SUBJECT: **NEW VEHICLE DEMONSTRATION / DELIVERY HOLD**
Safety Recall 20S69 – Supplement #1
 Certain 2021 Model Year Aviator Vehicles
 Front Wheel Knuckle Inspection

REF: **NEW VEHICLE DEMONSTRATION / DELIVERY HOLD**
Safety Recall 20S69
 Dated November 30, 2020

New! REASON FOR THIS SUPPLEMENT

FIGURE 1

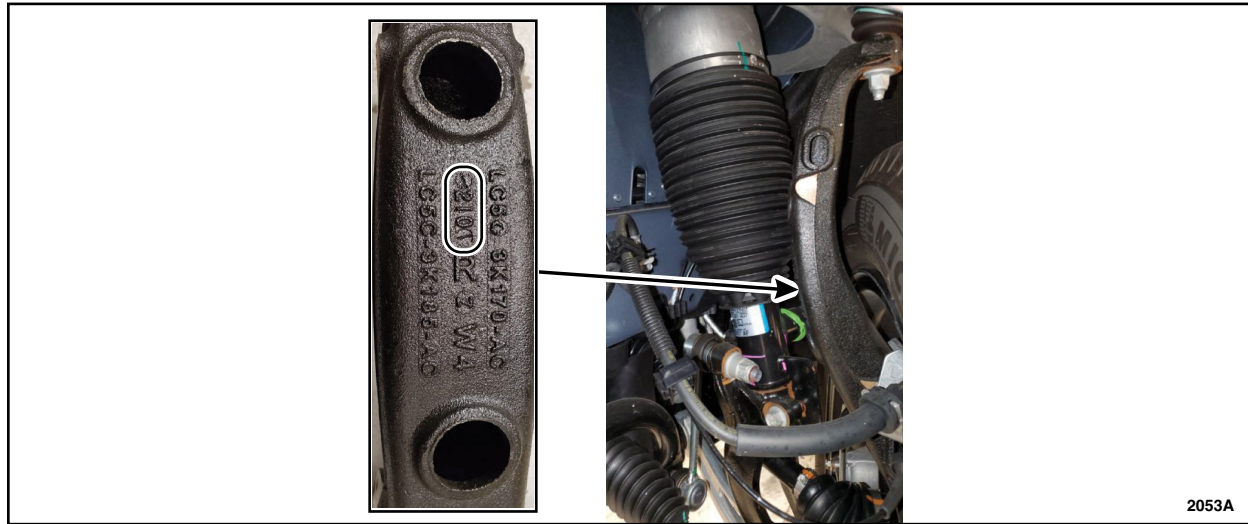
1. Turn the steering wheel to the full left position. Inspect and record the left hand wheel knuckle manufacturing date code. See Figure 1.

3. Is the date code for the LH side knuckle 298?

Yes – Does not pass inspection, replace the wheel knuckle. Proceed to steps 4 and 5.
No – Passes inspection, replacement not required. Proceed to step 4.

4. Is the date code for the RH side knuckle 296 **OR** 297?

Yes – Does not pass inspection, replace the wheel knuckle. Proceed to step 5.
No – Passes inspection, replacement not required. This recall is complete.
